# Browns Ferry Nuclear Plant Units 1, 2, and 3 Proposed Changes to NFPA 805 License Conditions

August 28, 2018

## Proposed Changes to NFPA 805 License Condition

## **MODIFICATION 106**

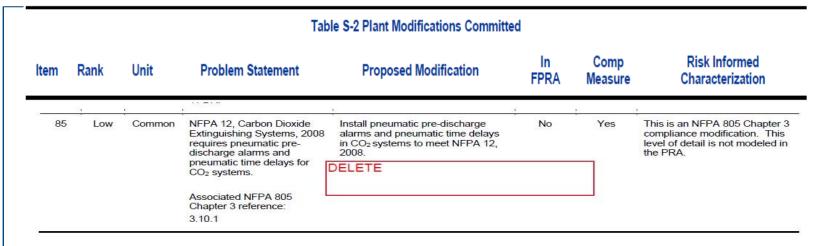
ltem	Rank	Unit	Problem Statement	Proposed Modification	In FPRA	Comp Measure	Risk Informed Characterization
106	Low	Common	When the RSW pumps and the water tanks are unable to maintain the pressure in the shared RSW and HPFP piping, a fire pump is activated to aid in maintaining pressure in the system.  Associated NFPA 805 Chapter 3 reference: 358	Install additional equipment to provide water to the cooling tower lift pump bearing lubrication water system in order to provide this system a water supply independent from the RSW and HPFP systems to ensure that pressure is maintained in the fire protection system during normal operation without using a fire pump.	No	Yes	Chapter 3 compliance modification. This level of detail is not modeled in the PRA.

- New intake station dedicated to bearing lube water.
  - Fire Pump currently needed to support Cooling Tower lift pumps

- Schedule is aggressive and more time may be needed if problems arise
- Extend due date to six months following then end of the outage i.e., October 14, 2019
